To: All Plan Holders of Record

Re: *Addendum No. 1*
Lake County Executive Airport Terminal
Lake Development Authority

Date: June 17, 2024

1 SECOND FLOOR PLAN
A1.02 1/4" = 1'-0"

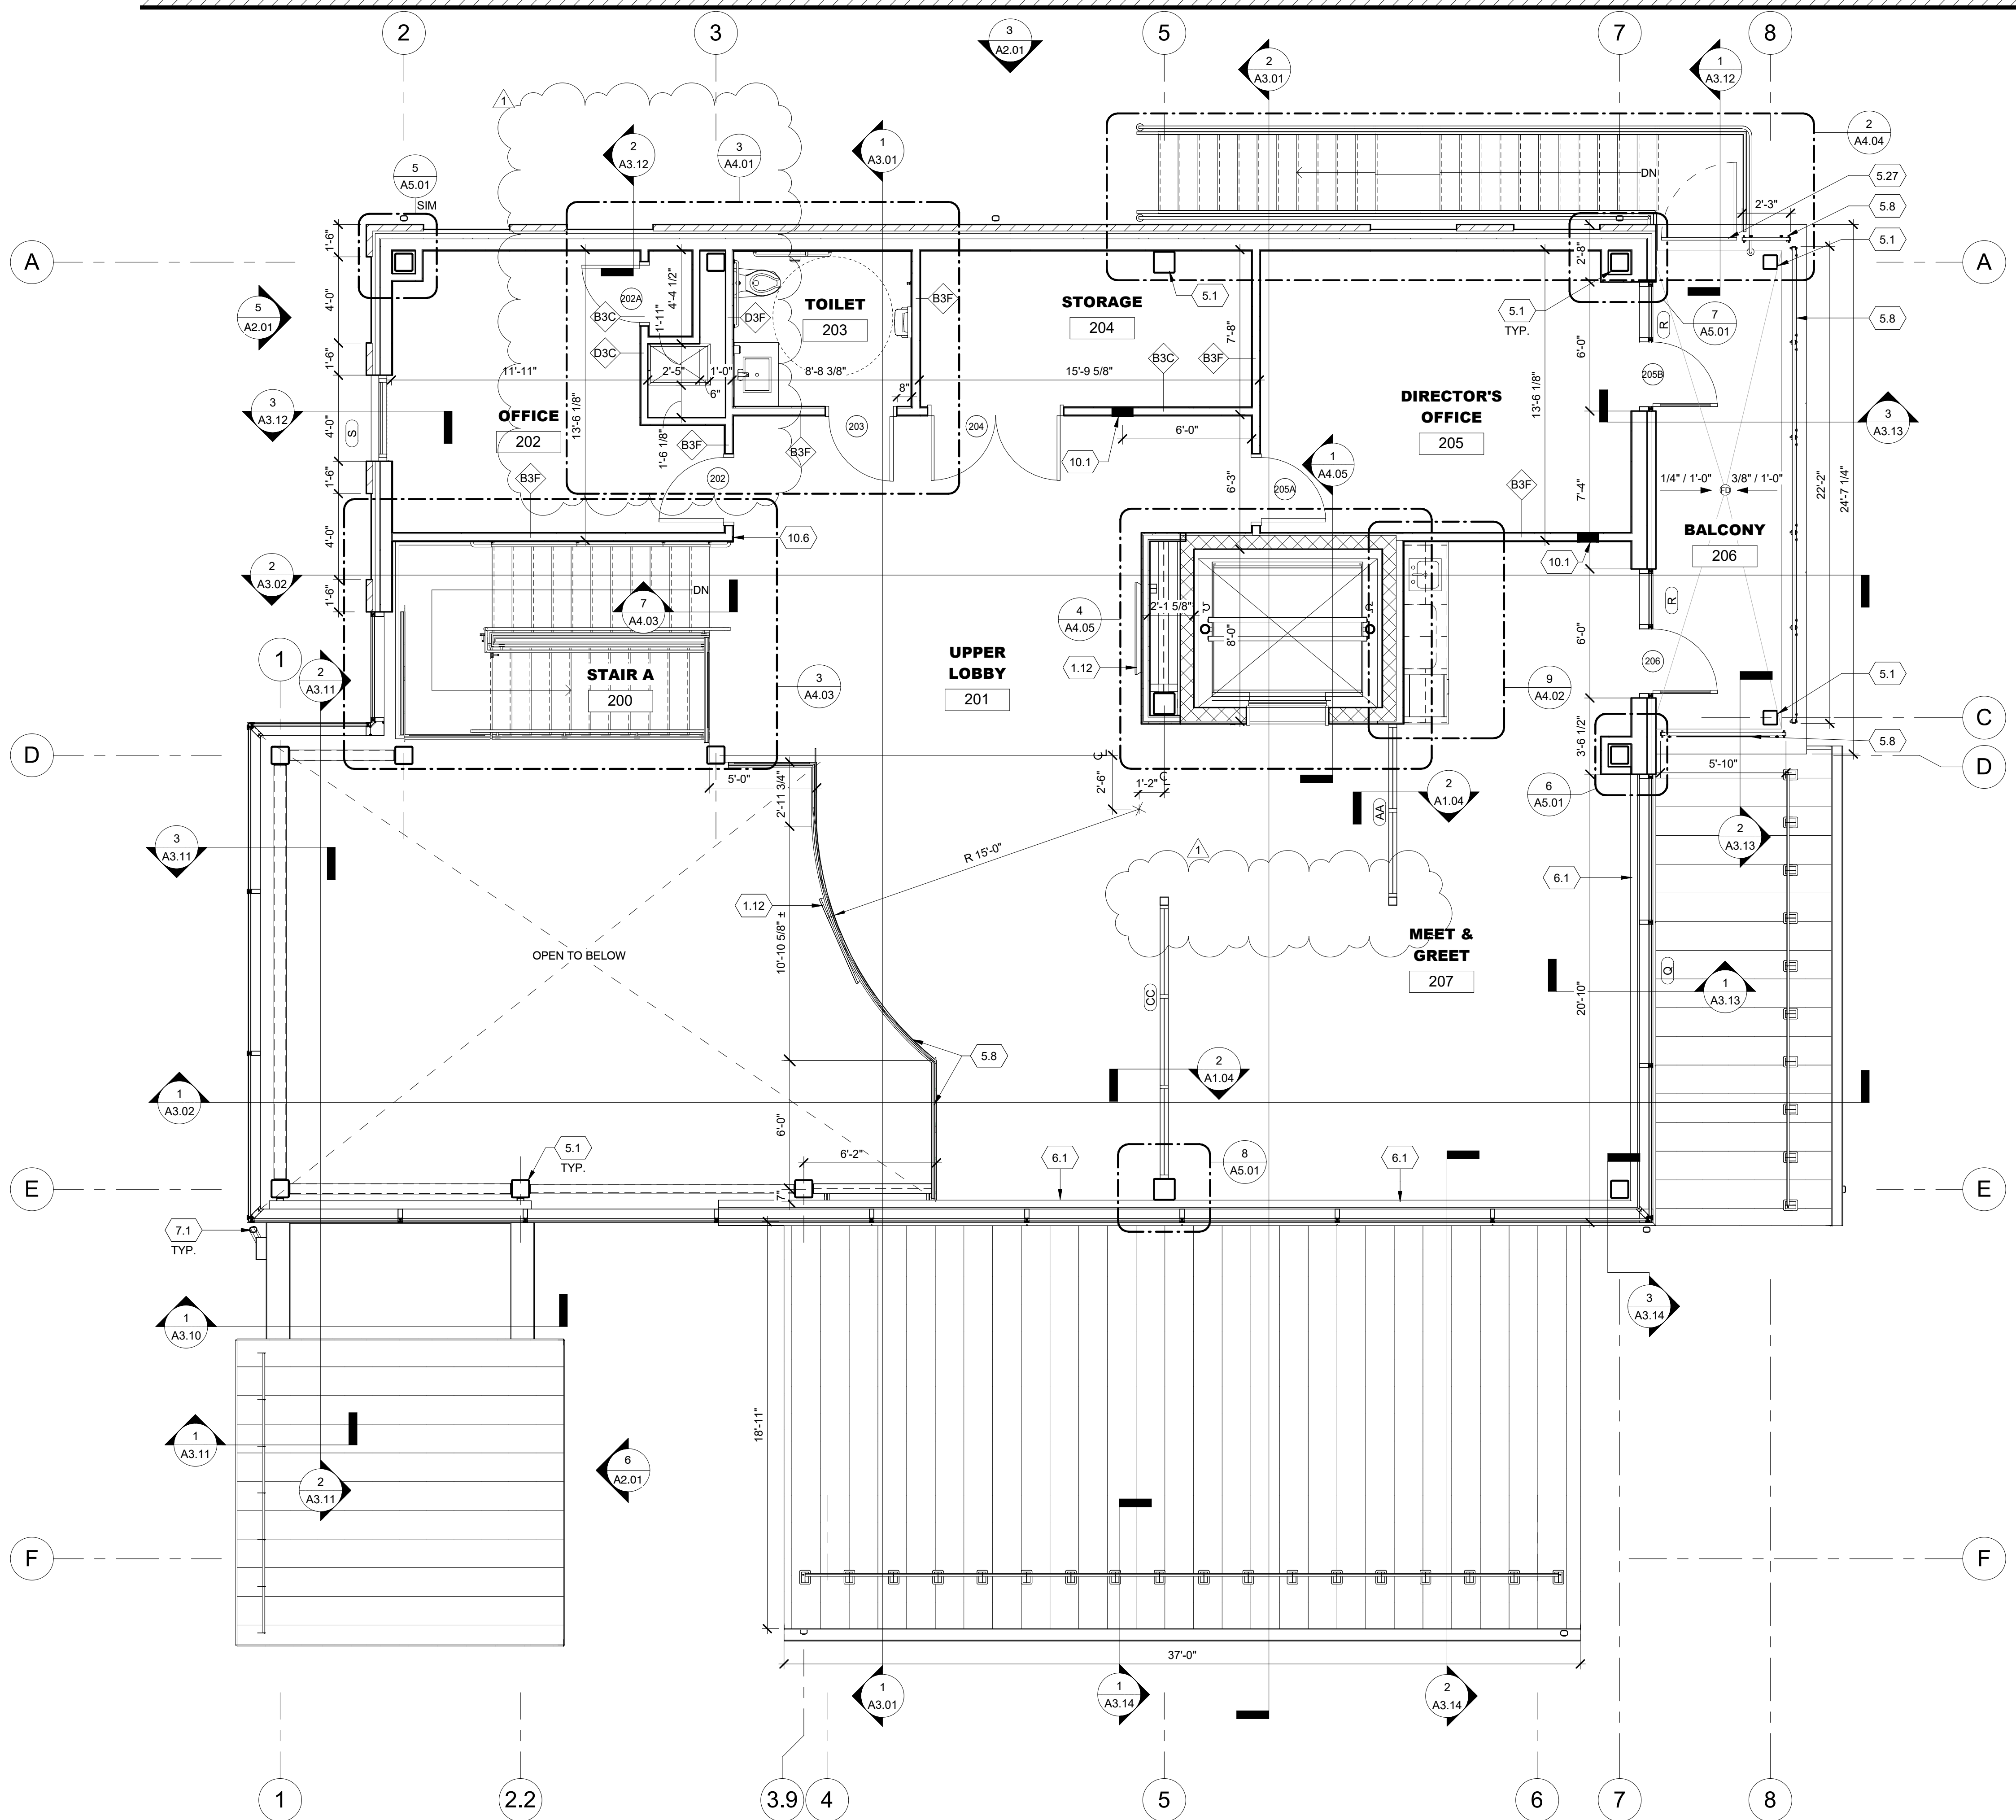
Reissued: A1.02 Updated Office 202 closet and door to allow for HVAC floor penetration.

44. Keynote 10.6 on drawings A1.01 & A1.02 refers to stainless steel corner guards but no spec section was provided for corner guards. Please provide.

45. General note O on A1.01 & A1.02 states to provide window shades at all exterior curtainwalls, no spec section or schedule has been provided for the window shades.

Response: 72 inch x 1 inch x 1 inch – 90 degree, 18 ga. Type 304, Satin #4 finish, stainless steel.

Response: Added specification section 122413 – “Roller Window Shades”.

1 REFLECTED CEILING SECOND FLOOR PLAN
A1.04 1/4" = 1'-0"

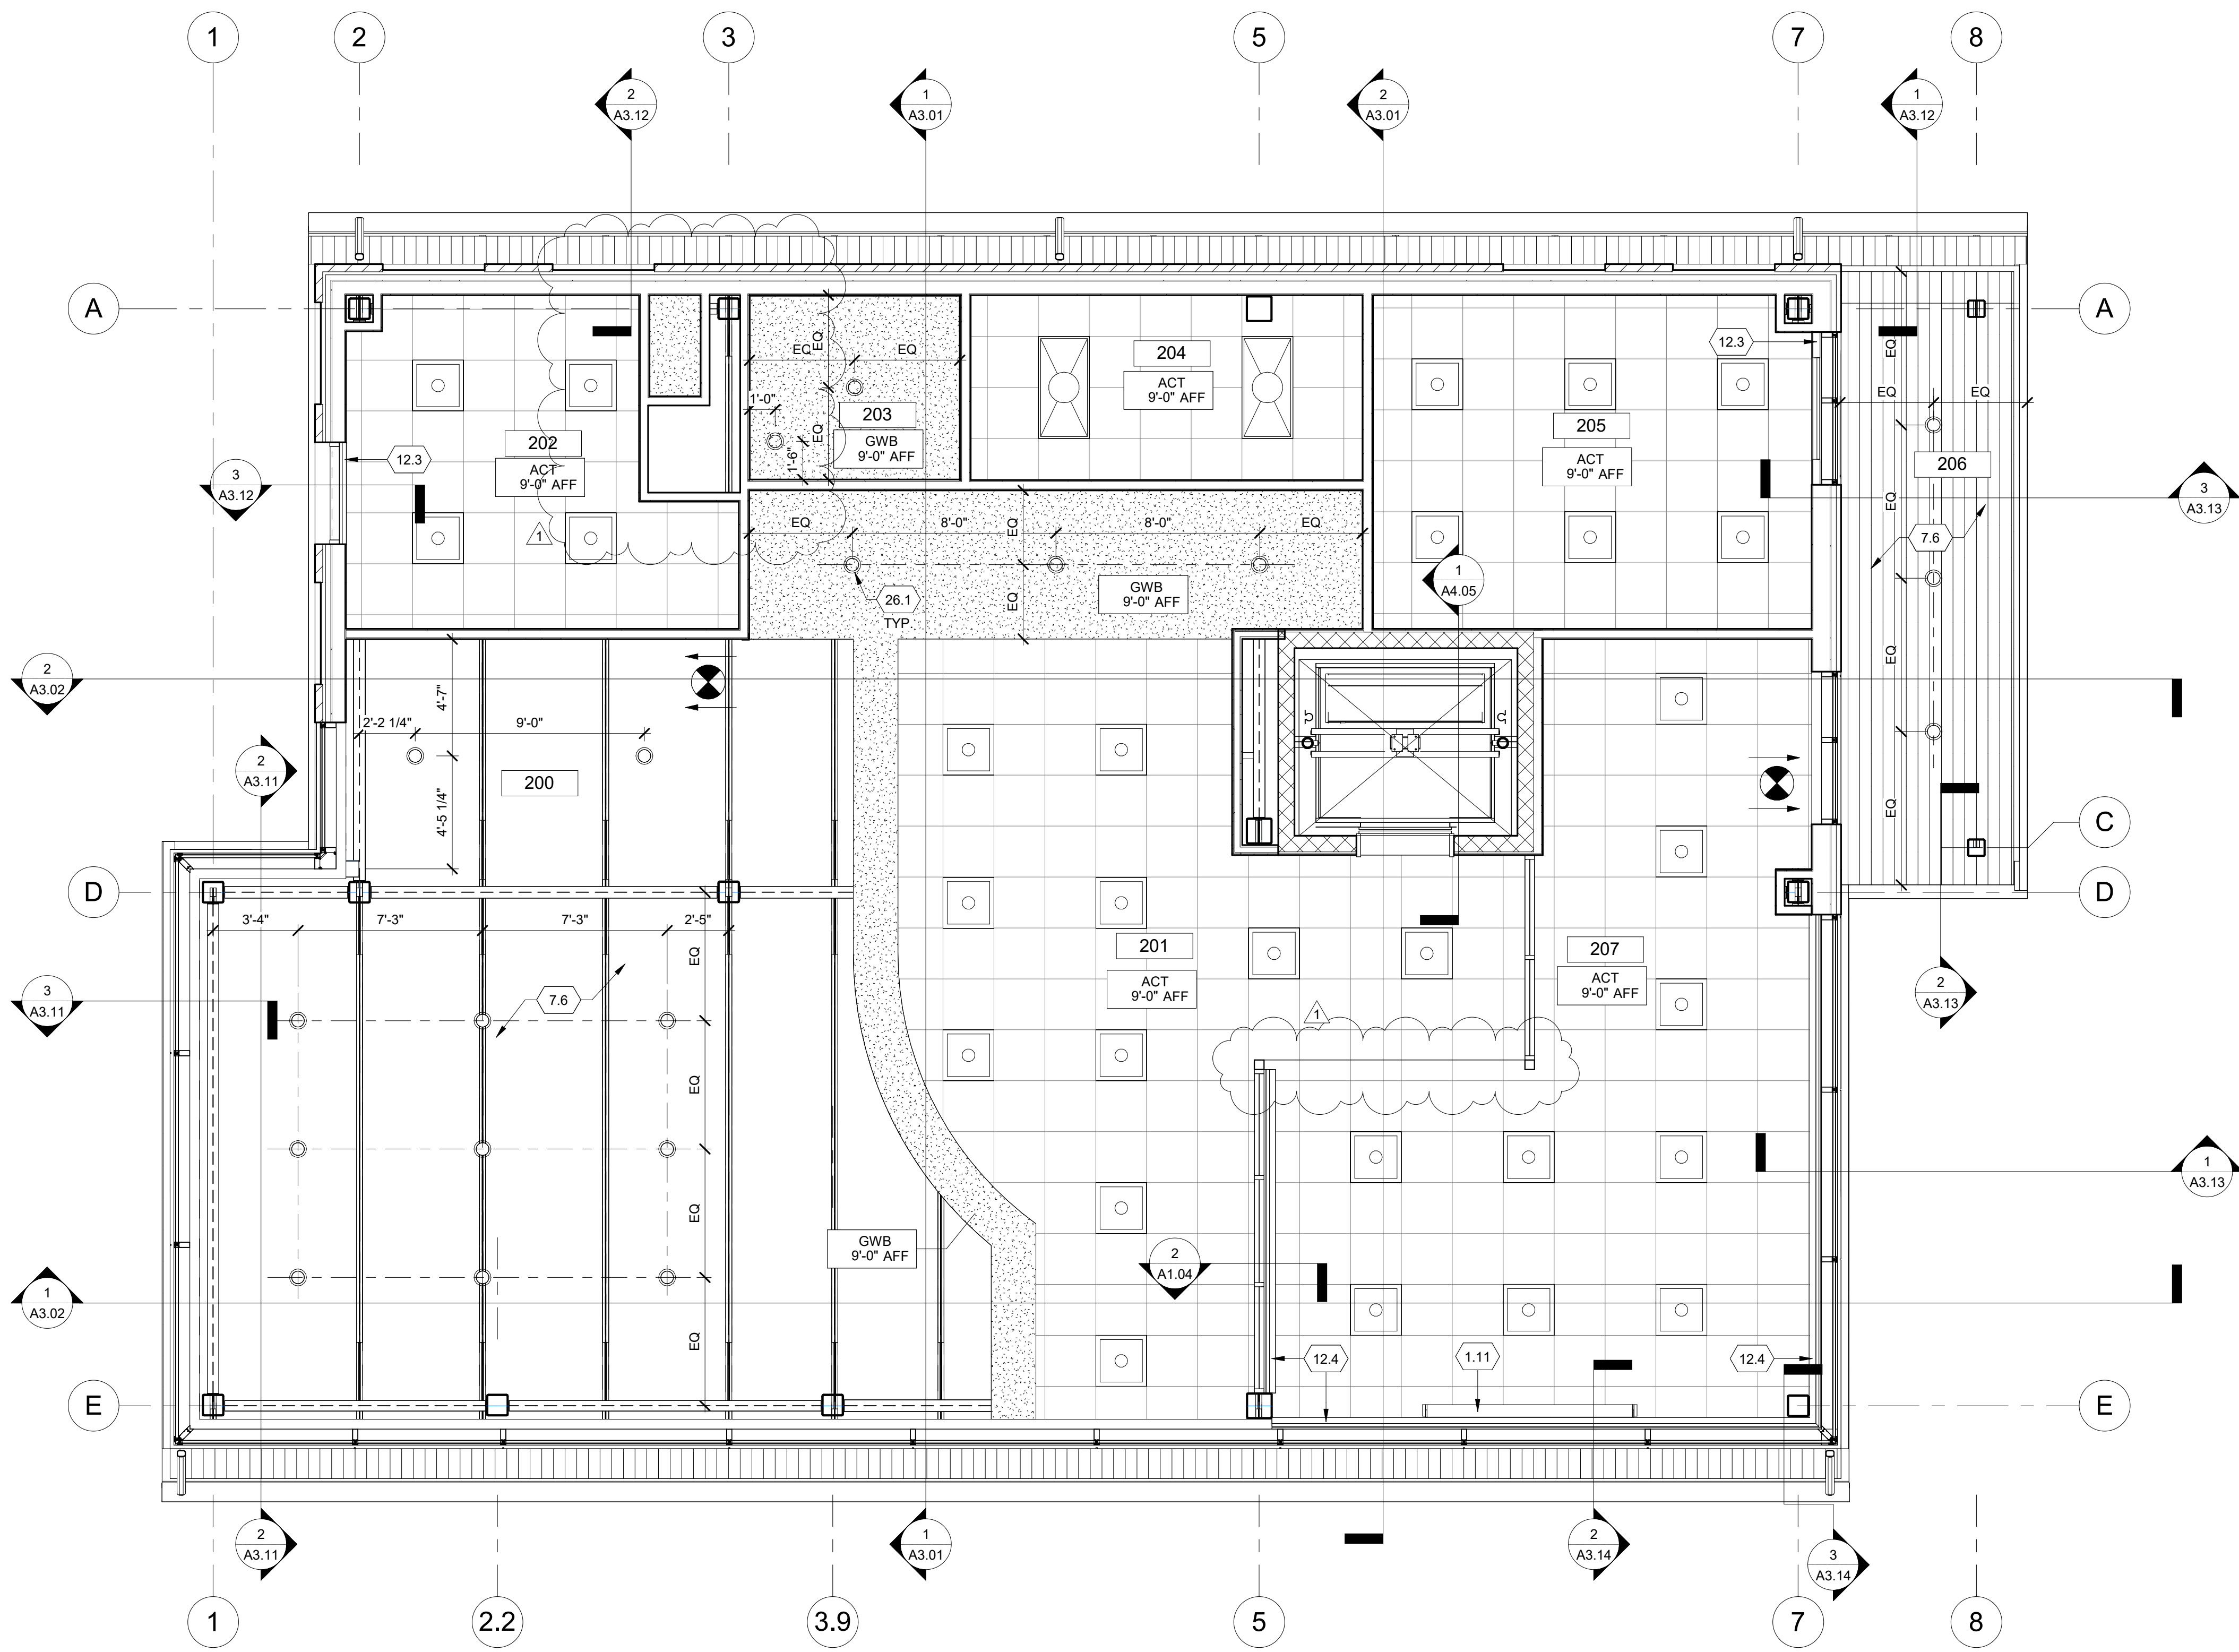
Reissued: A1.04 Updated Office 202 closet to allow for HVAC floor penetration.

3. Note 7.6 on drawing A1.04 states that the ceiling on the high lobby area is the be "prefinished linear metal soffit panels" However, on drawing A311, section 3, Note 5.13, it states that this ceiling is steel roof deck, paint where exposed". If this is determined to be a prefinished ceiling panels, do we paint the exposed trusses, mechanical, etc. below the decking?

Response: Underside of metal decking and all structural steel members, joists are to be painted where exposed.
